Access Compliance Report Public Rights-of-Way (Curb Ramps)

Intersection ID: 52127 Main Street: VALLEYDALE_RD Cross Street: FRED_D_ALEXANDER_BV Location: E

ADA ID: 26D249D4505D Ramp Type: Combination1 Initial Pass/Fail: Fail Overall Compliance: No Severity Score: 12.5

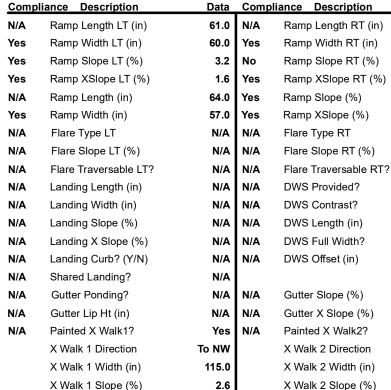
RP & LT RP < 5%

Not Found, R304.3.2

Remove & Replace Entire Ramp.
